#### **Project: IEEE P802.15 Working Group for Wireless Personal Area Networks (WPANs)**

Submission Title: comment and resolution about CID 33, 58, 34 and 59

**Purpose:** Contribution to IEEE 802.15.7 TG-VLC

Figure 20—Successful data transmission without an acknowledgment

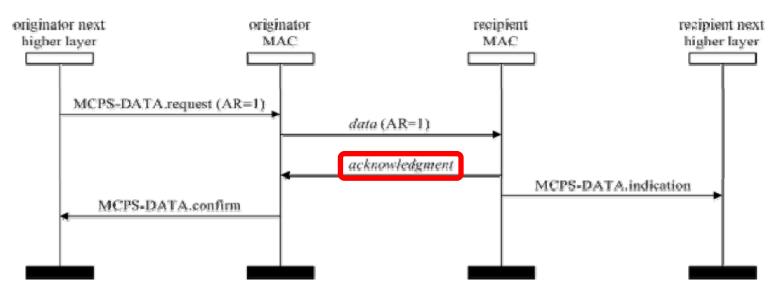
- Comment 33: Figure 20 has the title of "Successful data transmission without an acknowledgment", but the actual figure has AR=1, and shows an acknowledgement. I believe the wrong figure is here
- Comment 58: Text is about "without ACK". Buth the figure 20 describes about with ACK
- Comment 59: In "without ACK" case, AR should be "0". But AR=1 in figure 21.

- Comment 33: Put in the correct figure
- Comment 58: Change figure 20 with figure 21
- Comment 59: Change "AR=1" to "AR=0" in figure 21

- Resolution/instruction to editor
  - Swap figure 20 with figure 21
  - Then modify AR=1 to AR=0 in new figure 20
    - ◆ Subclause 5.1.7.4.1, page 46, line 26
      - In this case, the originator transmits the data frame with the Acknowledgment Request (AR) subfield of the frame control field equal to zero.

Figure 21—Successful data transmission with an acknowledgment

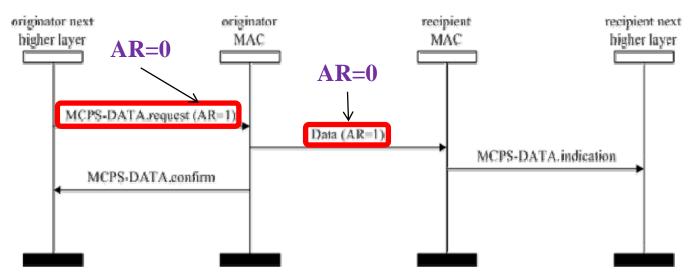
- Figure 21 has the title of "Successful data tr ansmission with an acknowledgment", but t he actual figure shows without an acknowle dgement.
- Comment is wrong.

Put in the corrected figure

- Resolution/instruction to editor
  - Change figure 21 with figure 20
